## Service Bulletin

<b>* Sujet:</b> Bulletin de service pour VC90**	
<b>* Date d'inscription:</b> 20110902	<b>* Effectif à partir du:</b> 20110902

<b>* Applicable aux modèles:</b> VC 9083 EX      VC 9084 DT      VC 9085 FS VC 9086 CH
--

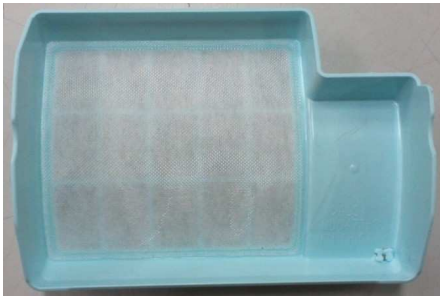
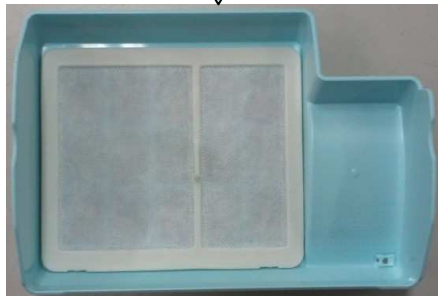
<b>* 1) Symptômes / Plainte Consommateur:</b>  Il est difficile de laver le filtre de sécurité du moteur
--

<b>* 2) Problème / Cause:</b>  filtre est coller à la trame.
--

<b>* 3) Solution:</b>  Le moteur filtre de sécurité est détachable du châssis.
--

Nous développons le filtre amovible.

**AVANT: Filtre tout en 1**

**Après: ajouter le filtre moteur amovible de sécurité**

**Châssis**

**nouveau moteur filtre de sécurité**

Before			
LOC.NO.	PART NO.	DESCRIPTION	IMAGE
MDQCF1	MDQ47360001	Frame,Filter

After			
LOC.NO.	PART NO.	DESCRIPTION	IMAGE
ADVTF1	ADV57024804	Frame Assembly,Filter
